# Impedance of new ALICE beam pipe

TREX meeting July 31st 2014

#### New geometry ALICE (1.2 m at 18.2 mm radius)

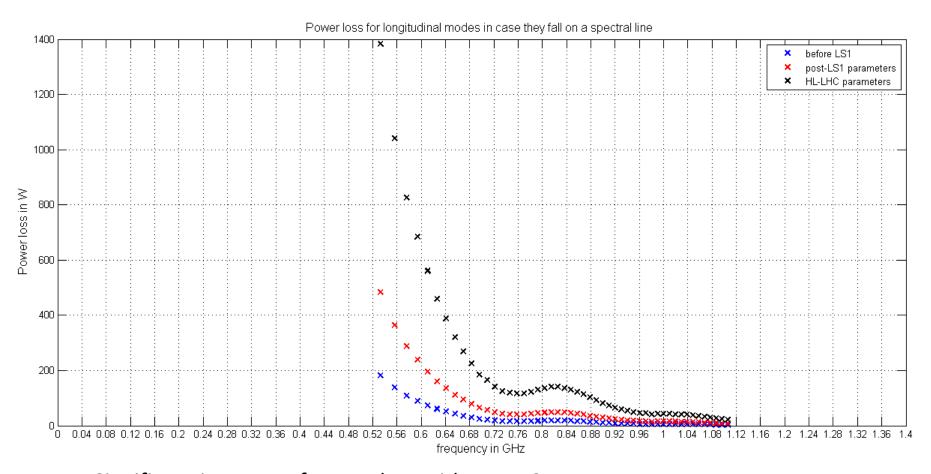
→ Are these values an issue?

- → Small impact on effective impedances (i.e. on single bunch stability)
- → Larger heating due to smaller aperture: can the beam pipe sustain 5 to 6 W/m in HL-LHC?
- → No link to the change of geometry, but potentially high heat loads due to modes could be obtained with HL-LHC beams in case the mode frequencies fall on beam spectral lines (already pointed out to LEB and HL-LHC management in 2013)

## Location of modes?

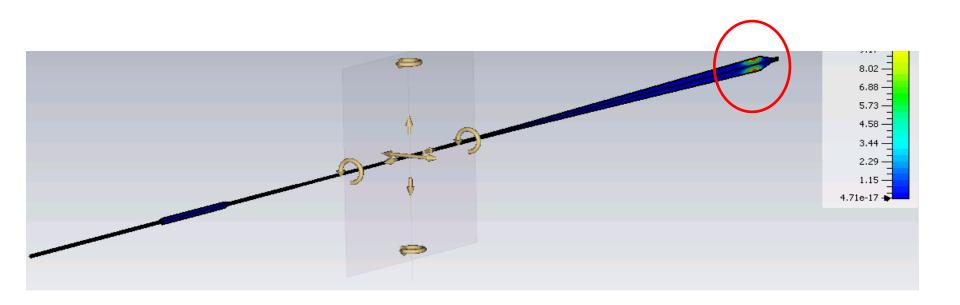
Linked to the large diameter of the cone  $\rightarrow$  localized there No changes foreseen in this area, so these modes are not affected by the upgrade

## ALICE aperture change request

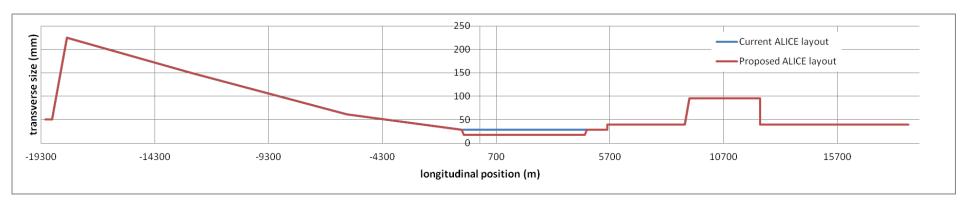
Nota: the new tapering angle is 7 degrees.

#### ALICE (Beryllium - length 5.317 m)

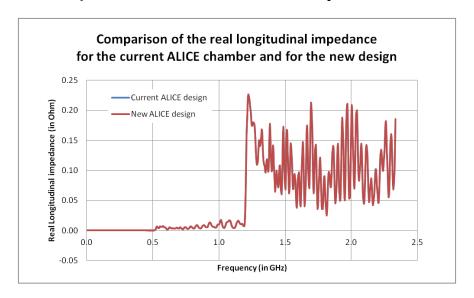
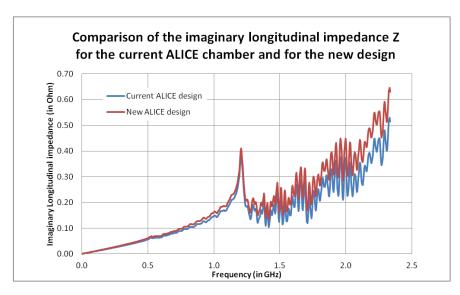
<sup>→</sup> significant increase of impedance with the new geometry. However, it remains very small compared to the total LHC impedance. Is a 70% increase in power loss ok?

## Longitudinal impedance (broadband computed from ABCI, all materials PEC)

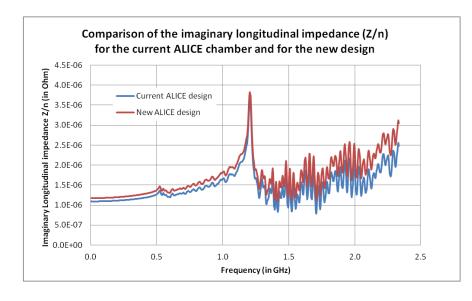
- No measurable difference in the real part of the impedance
- There is an increase of 7% of the imaginary part of the impedance
